COUNTY OF ALBEMARLE
Department of Community Development
401 McIntire Road, North Wing
Charlottesville, Virginia 22902-4596

RE: Review Comments on ZMA201200007 – 5th Street Commercial and SP201300027 – 5th Street Development Drive-Thru

FEMA LOMR 08-13-1390P

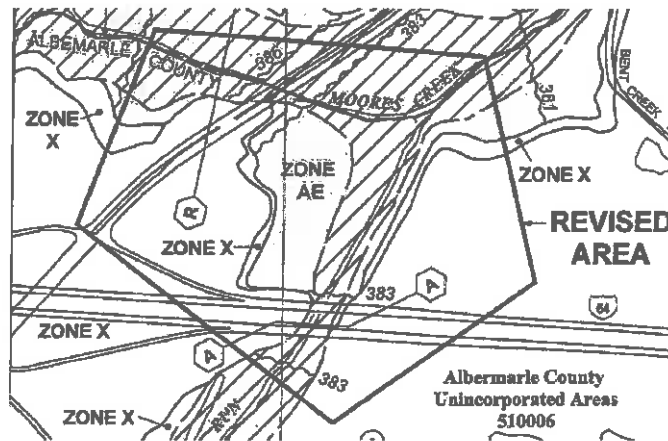
provided John McNair
plan, dated 4/29/2002,
"proposed FEMA 100-
limit" that appears to
contingent upon the
proposed with that

plan. Your new plan, dated 3/9/2015, shows what appears to be the same floodplain limits, labeled as "approved 100' year floodplain per approved FEMA map revision". This floodplain limit does not appear to be consistent with the FEMA LOMR dated 8/8/2008 (below). When/how were the floodplain limits you're showing approved? Is there a more recent LOMR for this area?
